TECHNICAL NOTE

File Ref: PZ/VL/P21-2319/01TN – Theberton House

Subject: Theberton House Estate – Deadline 6 Noise

**SIZEWELL CLINK ROAD: THEBERTON HOUSE ESTATE
Construction And Operational Noise Assessment**

Chart 5.1: Noise Monitor Results

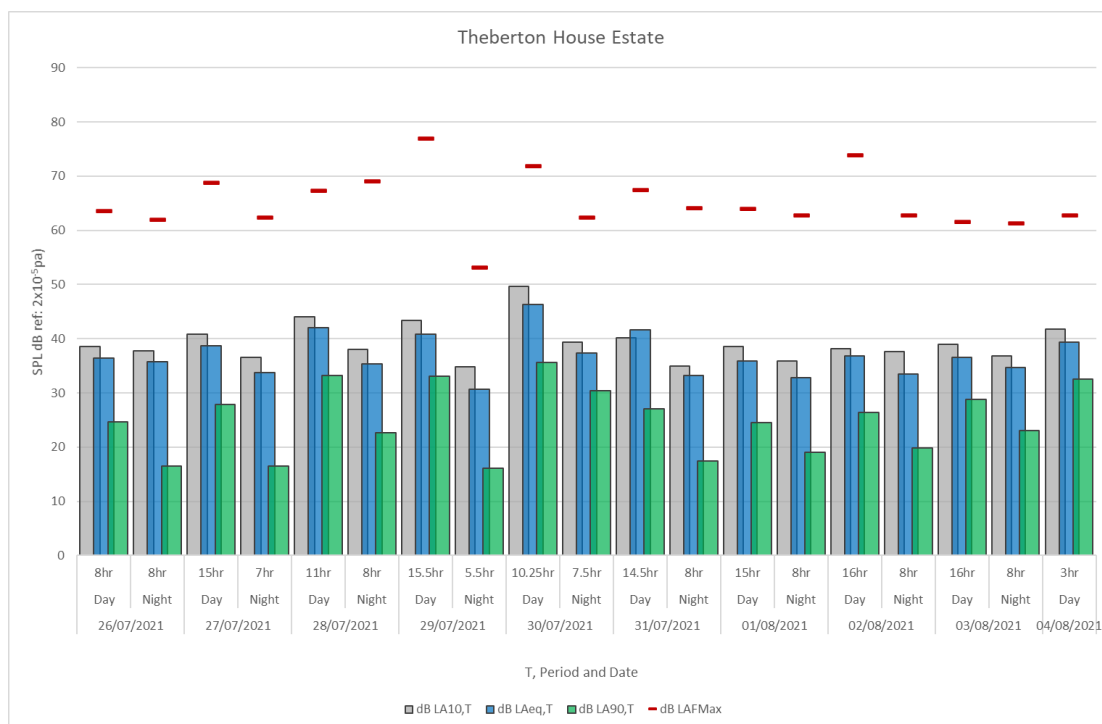
- 5.3 As can be seen in the table and chart above, the ambient levels remained very low, which is expected for this largely rural location. The most commonly occurring daytime ambient sound level at this location was 37 dB $L_{Aeq,1hr}$ and the daytime background sound level ranged between 18 and 39 dB $L_{A90,Day\ Time}$. The night time background sound levels were far lower, between 16 and 30 dB $L_{A90,Night(8\ hours)}$, but with a most commonly occurring night time background sound level of 30 dB $L_{A90,1hr}$.

- 5.4 The most representative monitor location in the EDF ES for the Theberton House Estate NSR was SLR 9, which was stated to be a typical measured daytime level of 43-44 dB $L_{Aeq,T}$. (Table 4.13, Book 6, Volume 6, Chapter 4). A detailed analysis of the measured sound levels was included within Book 6, ES Volume 2, Chapter 11, the Noise and Vibration Baseline Report.
- 5.5 Within the submitted document, the baseline sound levels were approximately 6-7 dB higher than those measured within the Create baseline sound monitoring for the day time ambient sound level, and the background sound levels were significantly higher.
- 5.6 Presumably the considerable difference was due to the reliance on three individual thirty minute measurements during the day and a single one hundred minute measurement at night time.

Figure 8.1: Phase 1a: No Mitigation Left & Phase 1a: With Mitigation Right

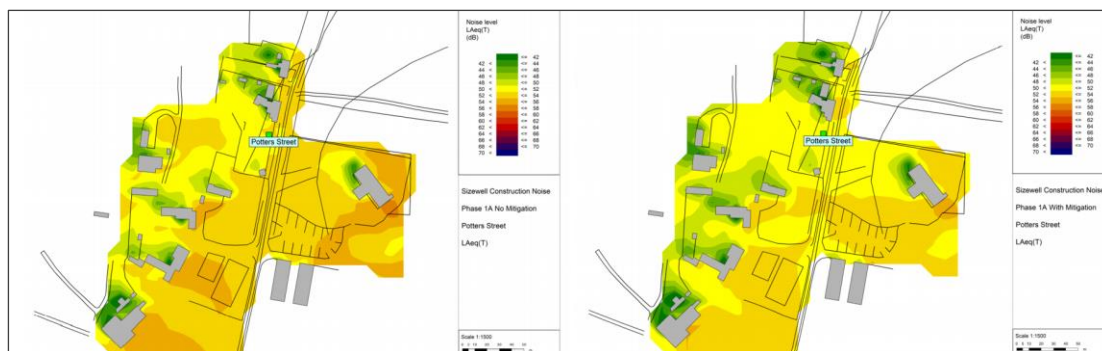
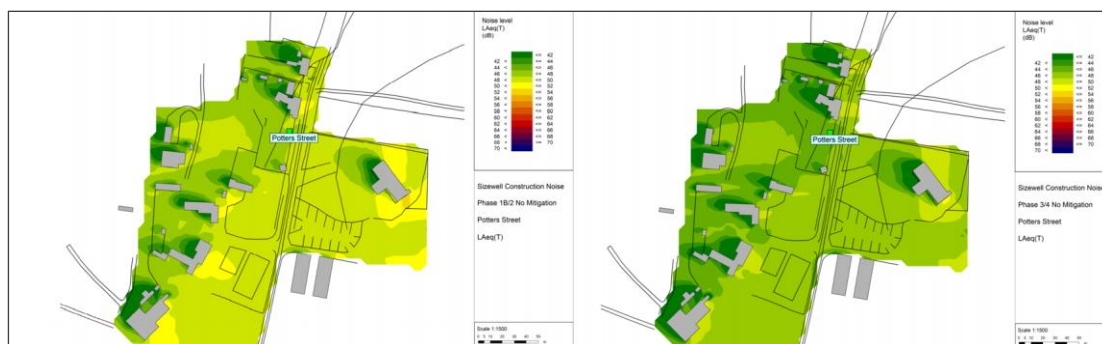
8.16 Book 6, Volume 2, Chapter, Appendices 11B includes the 3D noise propagation model used to determine the effects at the NSR. The following images can be found in the aforementioned document on pages 203 – 206. Note the residual ambient measured at the location (40 dB) is below the lowest contour in the legends ( <= 42).

- 8.17 It can be seen in the figures above that in all instances (both with and without mitigation), the predicted ambient would exceed the residual ambient measured. Given the works duration of >4 years, this change would be regarded as noticeable and detrimental.
- 8.18 Table 11.32 in Book 6, Volume 2, Chapter 11 defines the residual effects following mitigation at the various receptors around the site, for which receptor 18 is Theberton House Estate. The following table shows the assessment of effects following primary, tertiary, and additional mitigation measures during the works phases 1a and 1b:
